NO.	REVISION	APPV'D.	DATE
△1	REVISIONS DURING BIDDING	RPC	7/18/16

CONTINENTAL RANCH REGIONAL PUMP STATION UPGRADE DESIGN DISCRETE INPUT WIRING DIAGRAM - 2

R-2014-079
G-2014-078

SHEET NO. : E33
67 OF 91

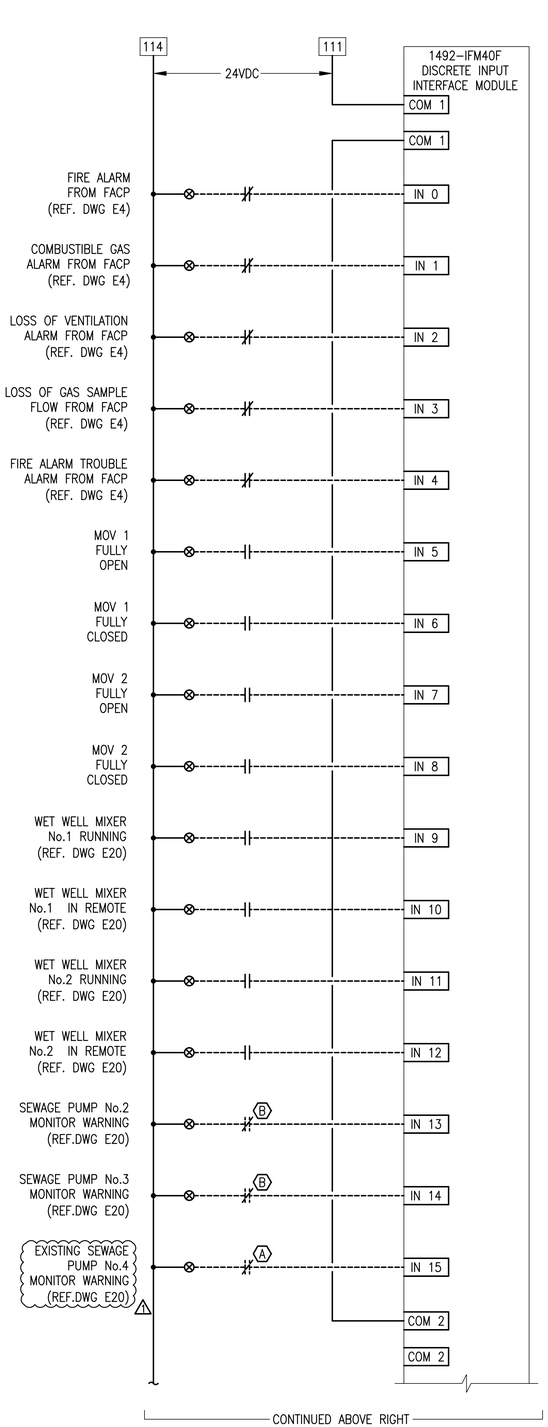
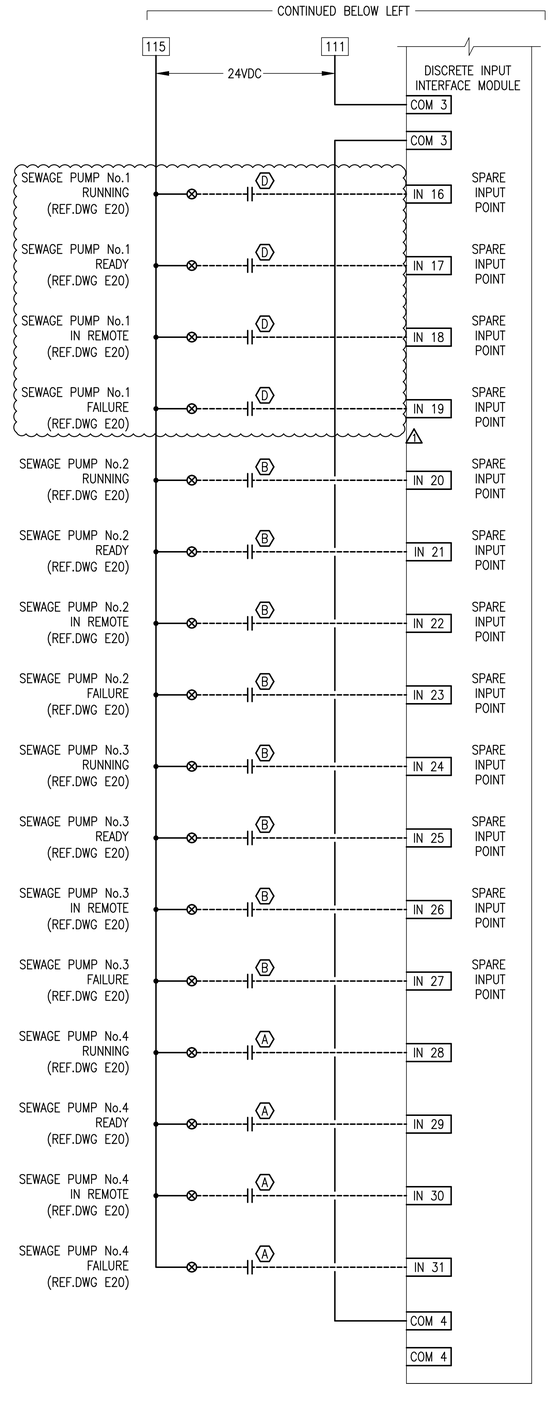
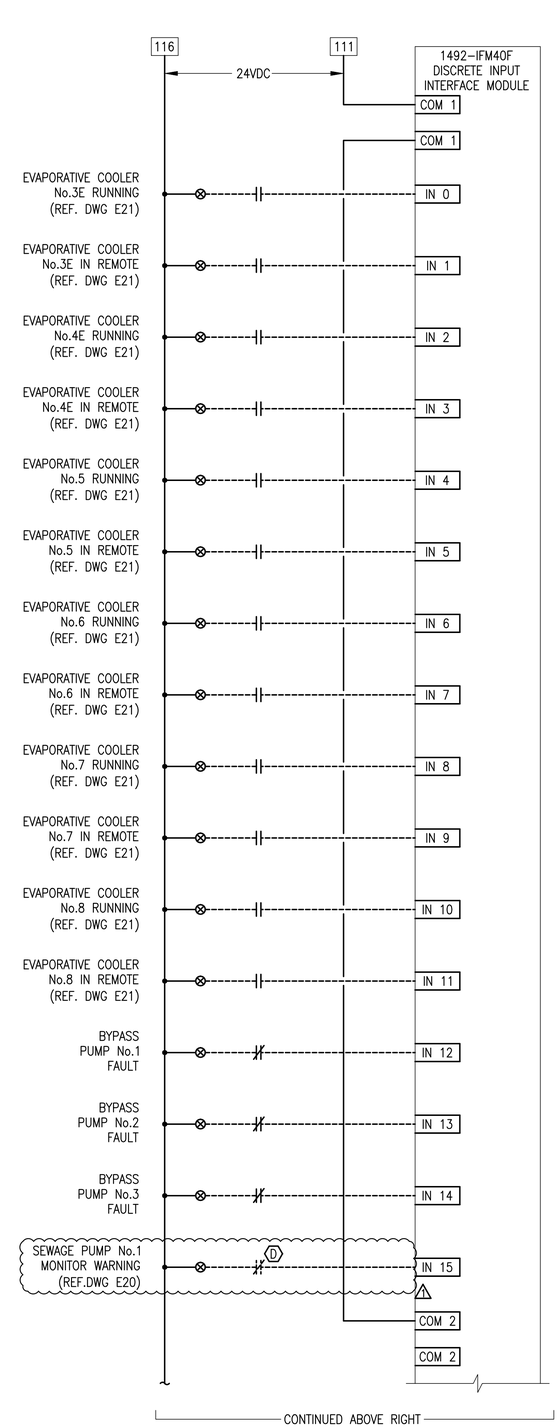
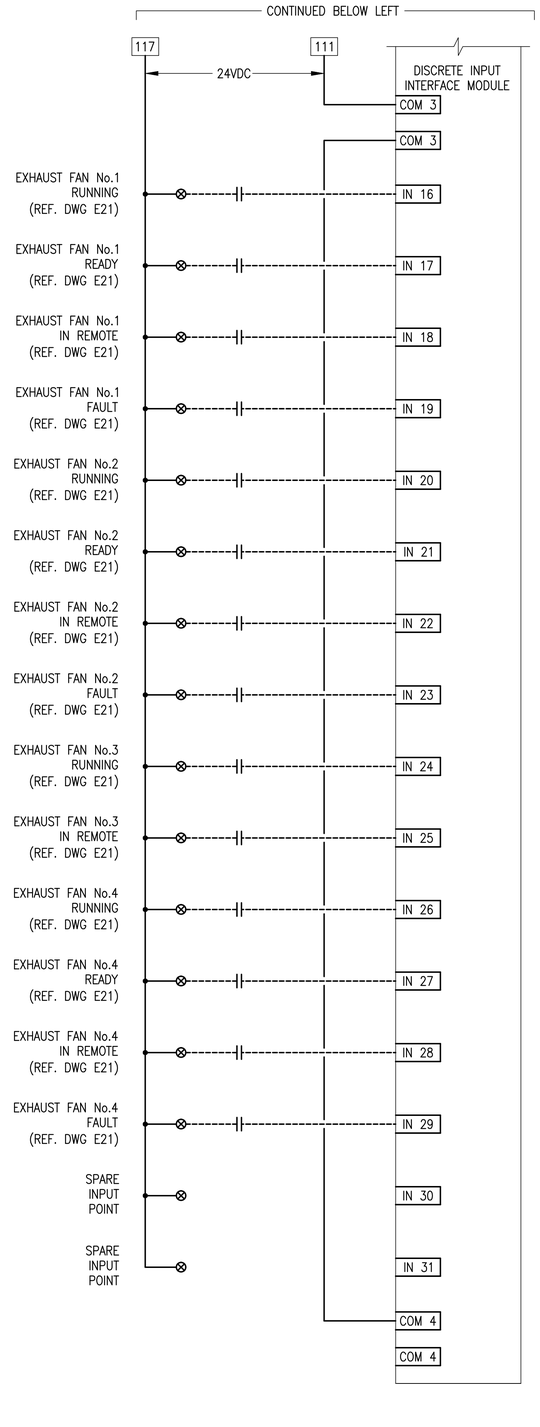
C. RUN 18#14, #14G (6#14 ARE SPARE) IN EXISTING SPARE 3/4" CONDUIT (CONDUIT C14C) FROM THE EXISTING EQUIPMENT PAD FOR PUMP No.1 VFD TO THE MAIN CONTROL PANEL. SEE CONDUIT SCHEDULE ON SHEET E101. 2#14 IN THIS RUN SHALL BE USED FOR THIS CIRCUIT. △1
